# UNITED STATES PATENT AND TRADEMARK OFFICE

APPLICATION NO.	FILING DATE	FIRST NAMED INVENTOR	ATTORNEY DOCKET NO.	CONFIRMATION NO.
10/709,681	05/22/2004	Carles Borrego Bel	8152ES	3680

**Office Action Summary**

## DETAILED ACTION

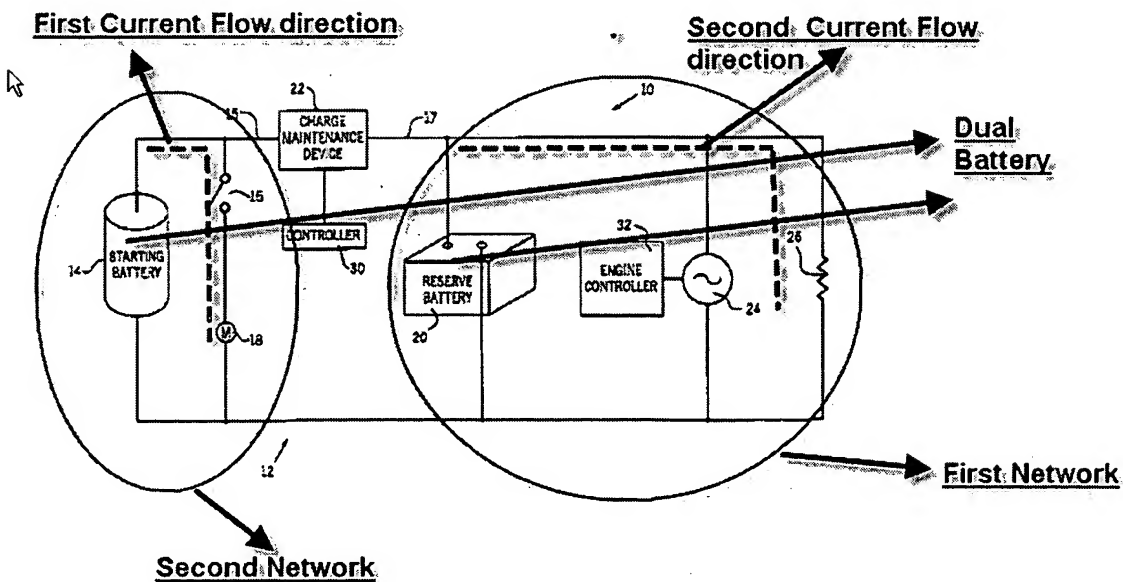
Dougherty et. al. disclose in Figures 1 and 2, a dual electrical network, a dual current flow direction and a dual battery. See figure below and also see paragraph 2, above on page 2.

Applicant also argues that references do not teach "bidirectional current flow". The claims do not have this limitation. Assuming, the applicant meant to refer "any direction" as in Claim 1. The flow of current to the load due to the reserve battery (20), and the flow of current to the element 18 due to the starting battery (14) meet the limitation (see figure above).
